Service Bulletin No: 52-005

Modification No: EC-14-0175

**CANOPY - GENERAL
INSPECTION FOR CORRECT INSTALLATION OF THE HINGE ATTACHMENT RIVNUTS****1. Planning Information****A. Effectivity**

Rivnuts - Inspection
Figure 1

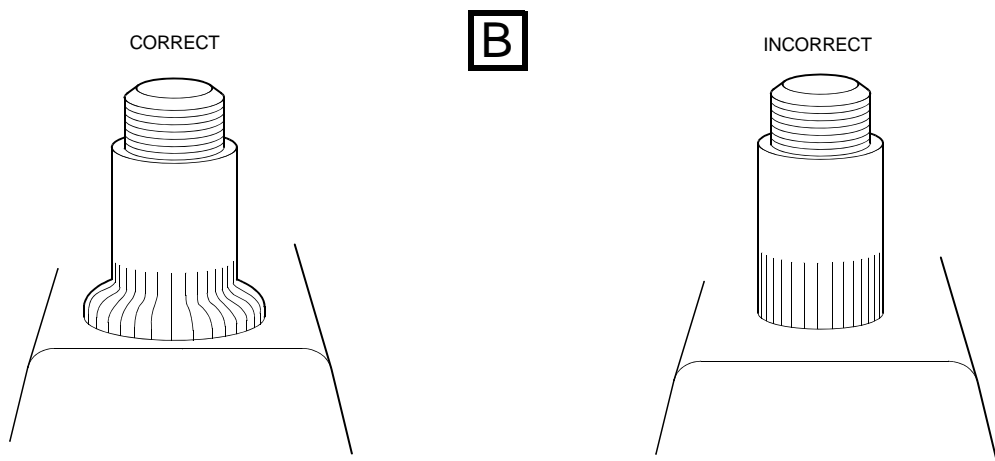
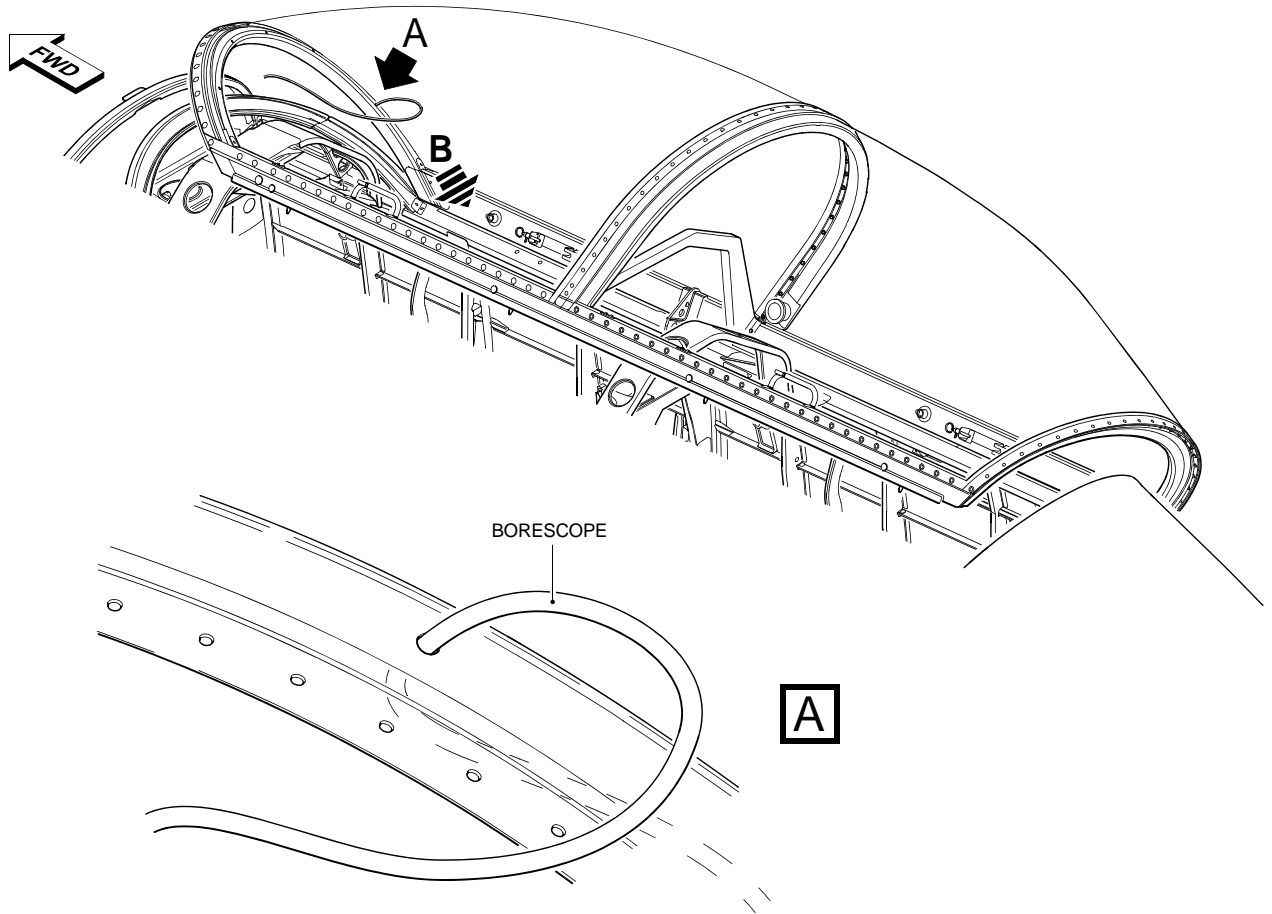
B. Inspection of the Rivnuts (Ref. Fig. 1)

- (1) Put the flexible borescope through the tooling hole in the right side of the front frame of the canopy.
- (2) Push the flexible borescope into the right side frame until you can see the rivnuts.
- (3) Examine the first four hinge attachment-screw rivnuts (minimum).
- (4) If the rivnuts have a bulge they are correctly installed. Remove the borescope and do the re-identification procedure (Ref. Para. F.).
- (5) If the rivnuts are cylindrical with no bulge they are not correctly installed. Continue with the rivnut installation procedures.

- (1) Put the flexible borescope through the tooling hole in the right side of the front frame of the canopy.
- (2) Push the flexible borescope into the right side frame until you can see the rivnuts.
- (3) Examine the first four hinge attachment-screw rivnuts (minimum).
- (4) If the rivnuts have a bulge they are correctly installed. Remove the borescope and do the re-identification procedure (Ref. Para. 4.C.).
- (5) If the rivnuts are cylindrical with no bulge they are not correctly installed. Do the rivnut installation procedure for all the rivnuts for the hinge attachment screws (Ref. Para. 4.B.).

FIG. 2a
INSTALL TOOL

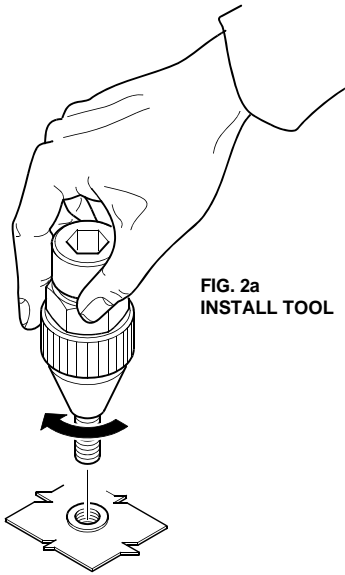
- (1) If the rivnuts are serviceable, use the Rivnut Handtool (P/N 513.53.09.029) and pull the rivnuts as follows (Ref. Fig. 2):
 - (a) Install the hand tool in the rivnut (Ref. Fig. 2a):
 - 1 Engage the threads of the pull-up stud (on the hand tool) with the threads of the installed rivnut.
 - 2 Turn the complete tool clockwise to fully install the pull up stud in the rivnut.
 - 3 Turn the anvil until it is tight against the head of the rivnut.

FIG. 2b
PULL RIVNUT

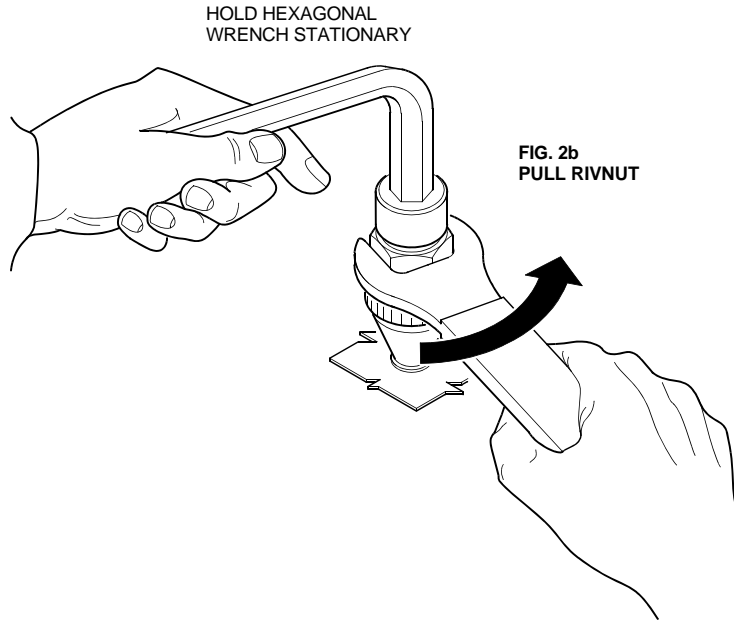
- (b) Pull the rivnut (Ref. Fig. 2b):

CAUTION: MAKE SURE YOU HOLD THE HAND TOOL PERPENDICULAR TO THE SURFACE OF THE CANOPY FRAME. YOU MUST NOT INSTALL THE RIVNUT AT AN ANGLE.

- 1 Insert the hexagonal wrench in the jackscrew of the hand tool.

CAUTION: DO NOT PERMIT THE HEXAGONAL WRENCH TO TURN WHEN YOU PULL THE RIVNUT. DAMAGE TO THE HANDTOOL CAN RESULT.

- 2 Hold the hexagonal wrench stationary.

CAUTION: DO NOT TURN THE LARGE HEXAGONAL NUT MORE THAN 3/4 OF A TURN. DAMAGE TO THE HANDTOOL CAN RESULT.

- 3 Use a wrench to turn the large hexagonal nut counter-clockwise for 3/4 of a turn.

NOTE: 3/4 of a turn is the maximum required to completely deform the sleeve of a rivnut that is not correctly installed.

FIG. 2c
LOOSEN TOOL

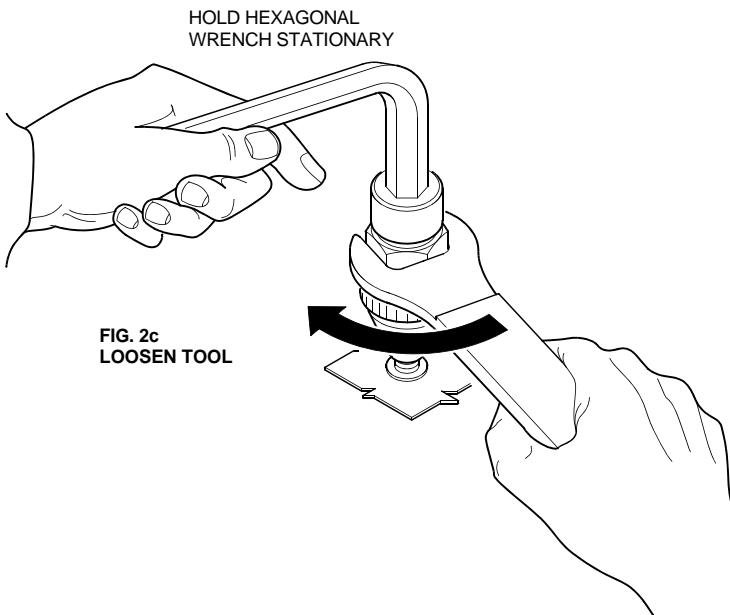
- (c) Loosen the hand tool (Ref. Fig. 2c):

- 1 Hold the hexagonal wrench stationary.

- 2 Break the large hexagonal nut loose with a clockwise turn.

- 3 Remove the two wrenches from the hand tool.

FIG. 2d
REMOVE TOOL

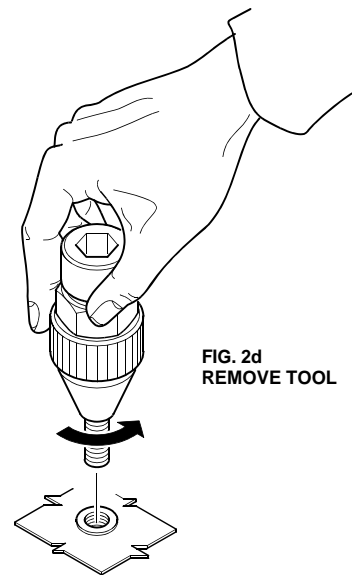
- (d) Remove the hand tool (Ref. Fig. 2d):

- 1 Turn the complete tool counter-clockwise to remove the pull-up stud from the rivnut.

- 2 Remove the hand tool.
